SYDNEY METRO CITY & SOUTH WEST
CONSTRUCTION TRAFFIC MANAGEMENT PLAN
CROWS NEST SITES
 APRIL 2017

CTMP Review Comments Sheet

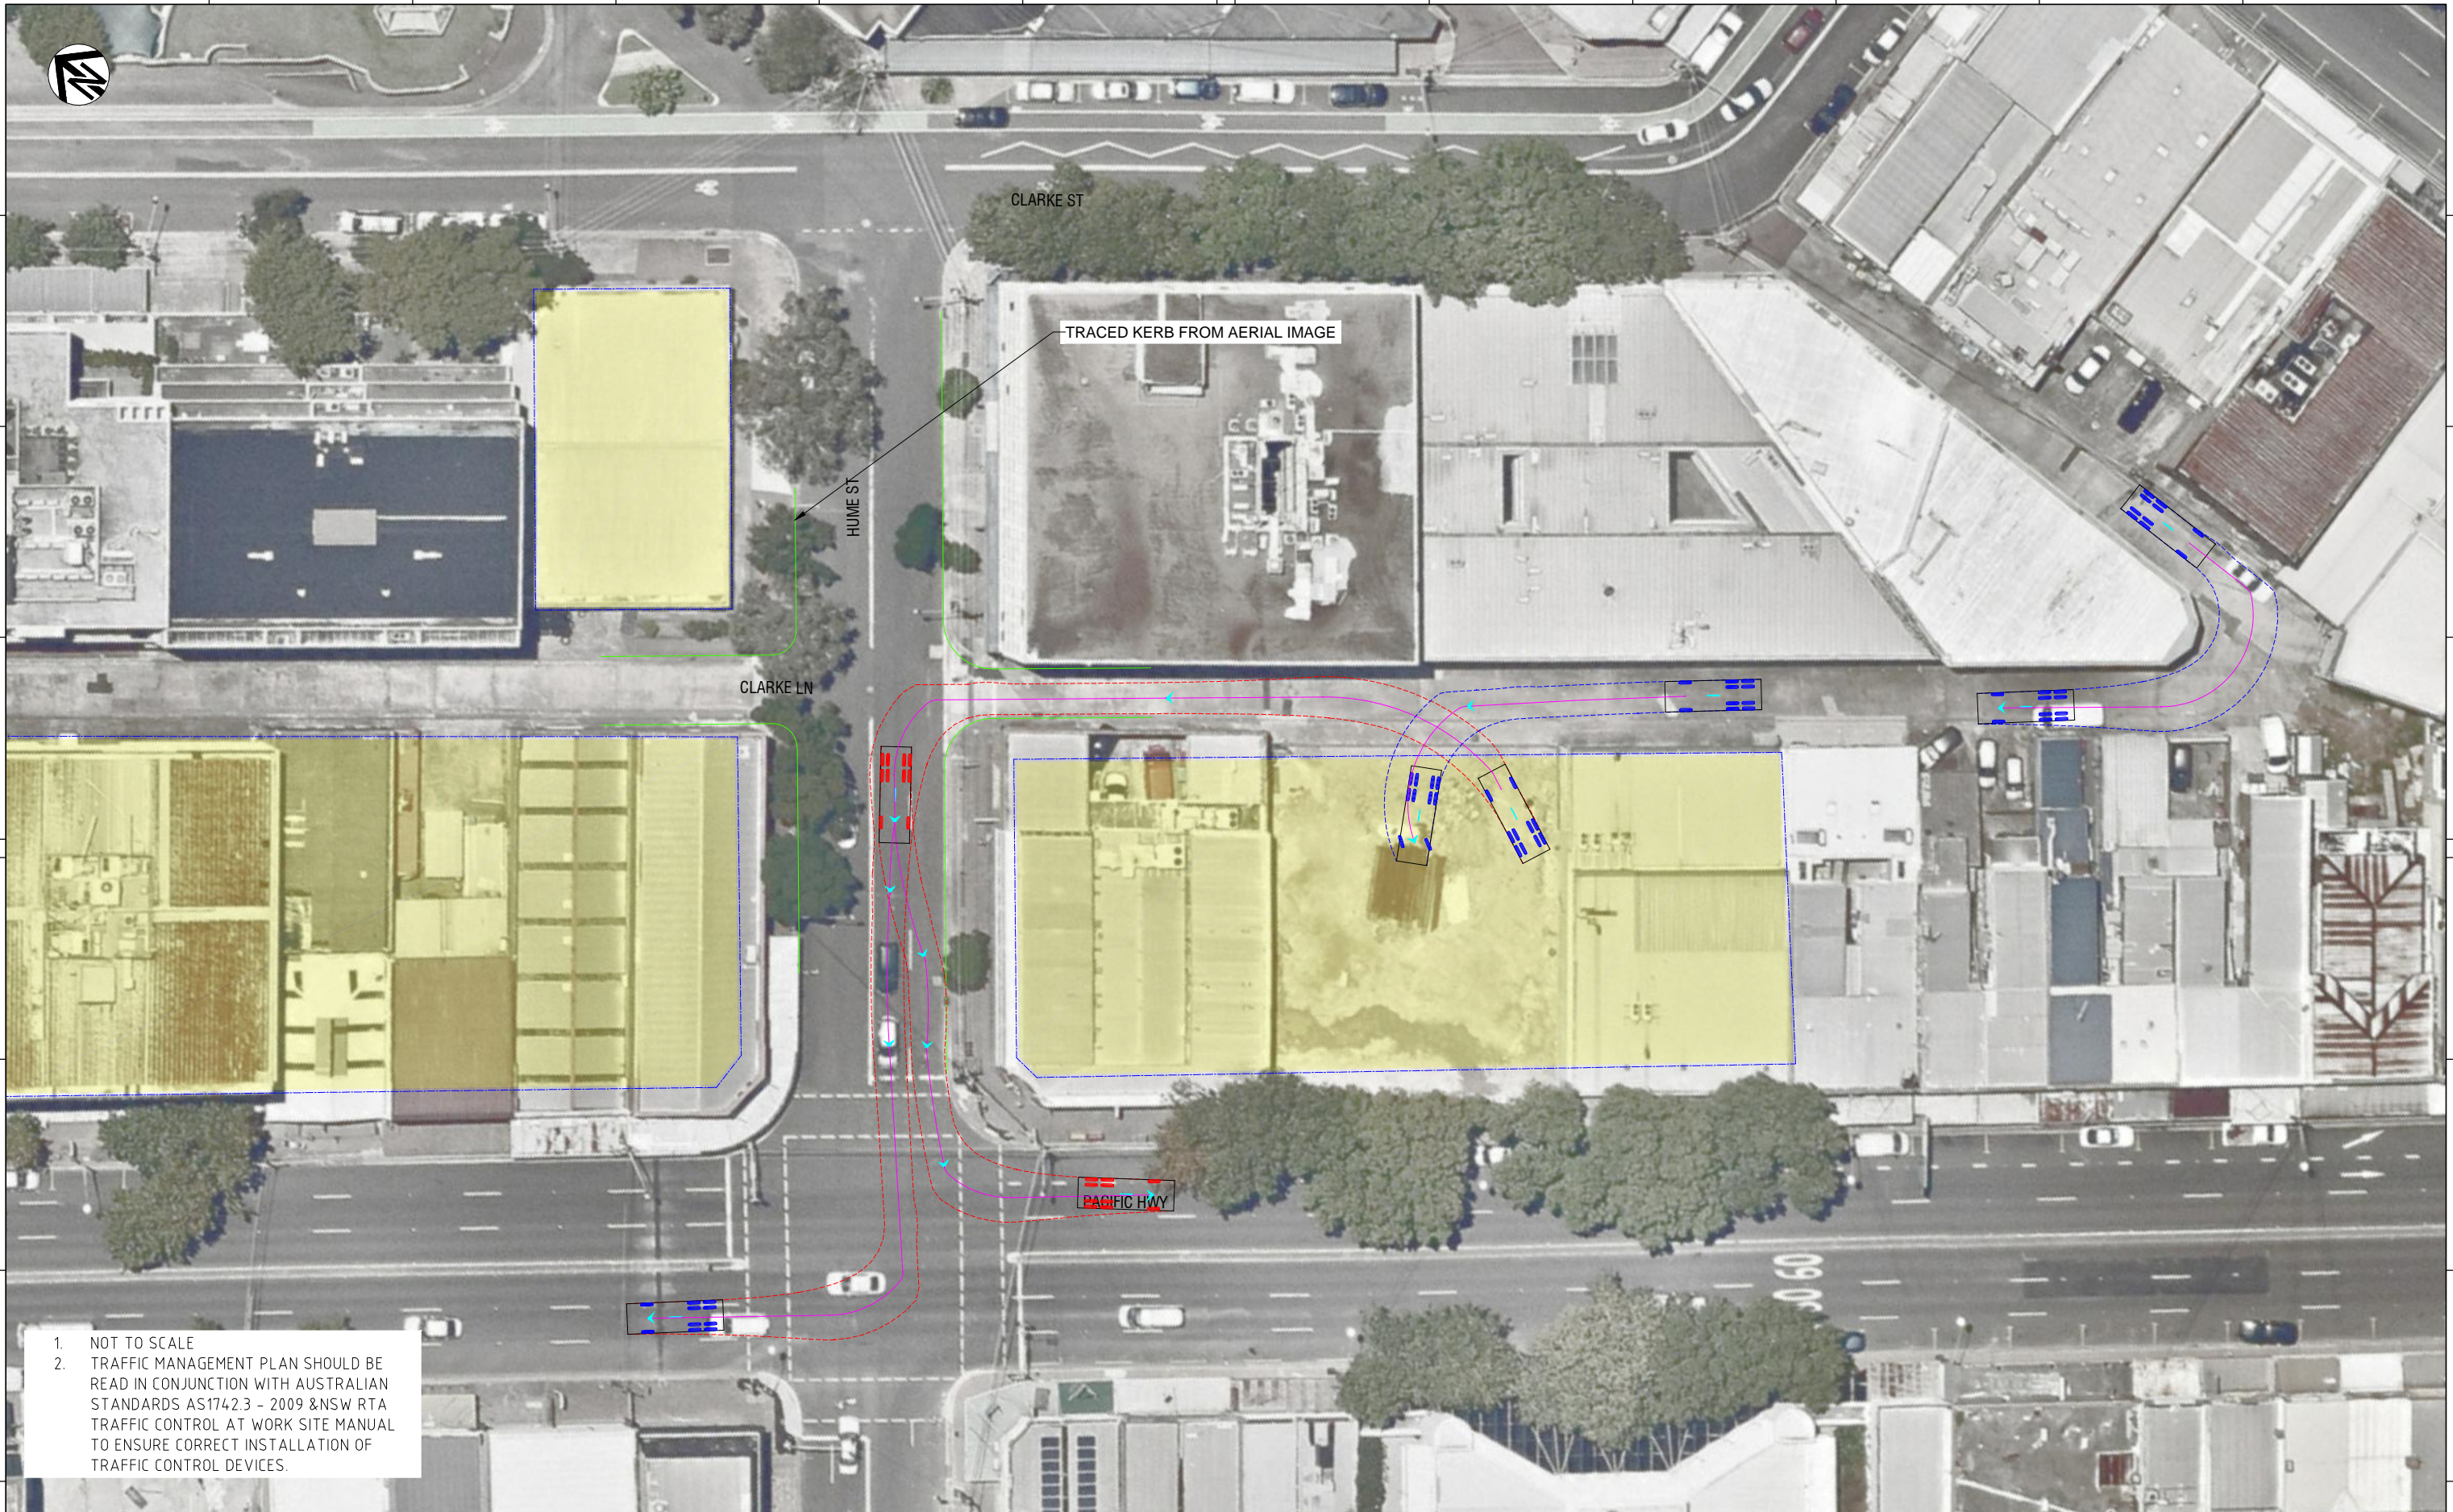
Item	Section/ Page	Comments	Response
7	3.2.2.1 & App 2 DWG 0003-03	<p>The legend shows a green area representing "Scaffold off ground, A or B Class". It is not clear how a B Class hoarding would work in Clarke Lane due to the very narrow footpaths. North of Hume Street the footpaths are wider on the eastern side of Clarke Lane and south of Hume Street the footpaths are wider on the eastern side of Clarke Lane. Will pedestrian access be able to be maintained on the wider footpaths with the hoarding/scaffolding?</p> <p>Approval must be obtained from Council for all temporary construction hoardings. Application form is available on Council's website at https://www.northsydney.nsw.gov.au/Building_Development/Building_DA_Forms/Construction_Forms#4</p>	Document amended.
8	4 & App 2 DWG 0003-04	Swept path diagrams in and out of Clarke Lane at Hume Street show truck and dog trailers will over-run the footpaths. This truck type is therefore unsuitable and a smaller truck must be used. No truck and dog trailers are to be used for this site.	Document and drawings amended

DRAWING No:	DD-SYDM-DWG-0003-08		
SHEET	1	OF	1
REVISION	A-00

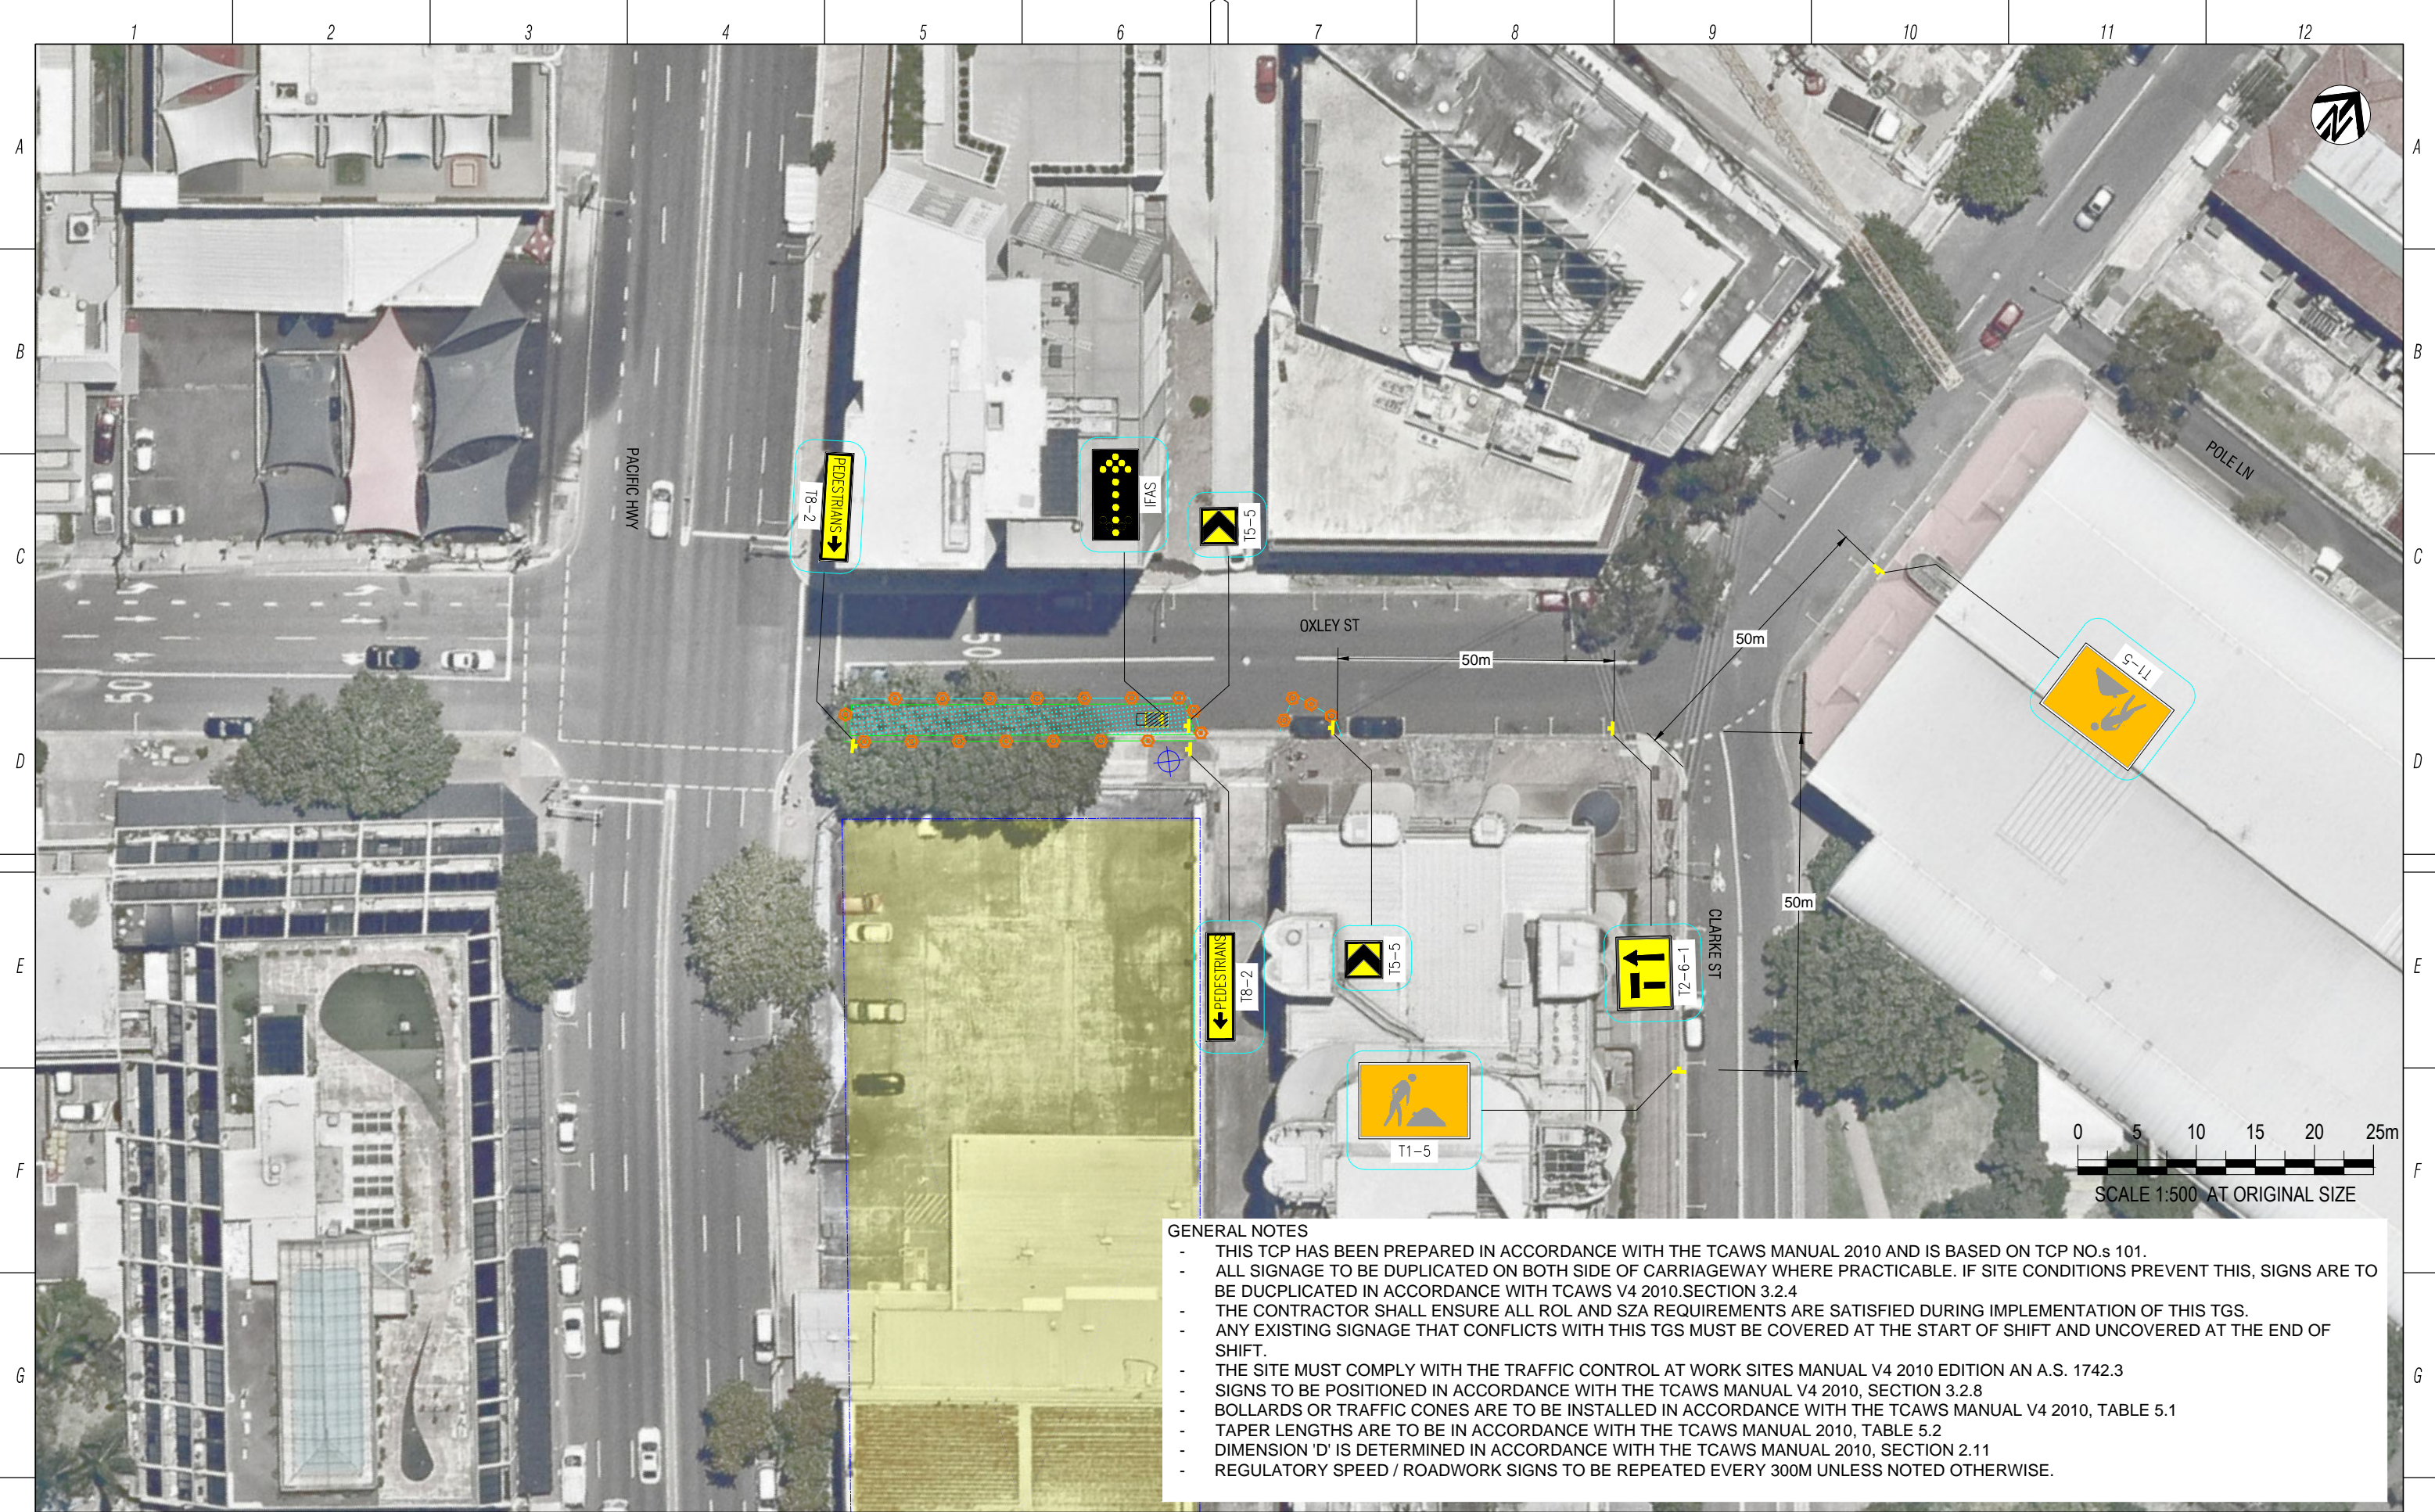
12	Appendix 3 Drawing DD-SYDM-DWG- 0003-08	The schedule notes this plan is for a slow lane closure on Oxley Street for driveway construction. There is an existing driveway in Oxley Street which is proposed to be used for construction egress, however no modifications to the driveway are proposed elsewhere in the CTMP. Clarification needed as to what activity this TCP is for.	Document amended
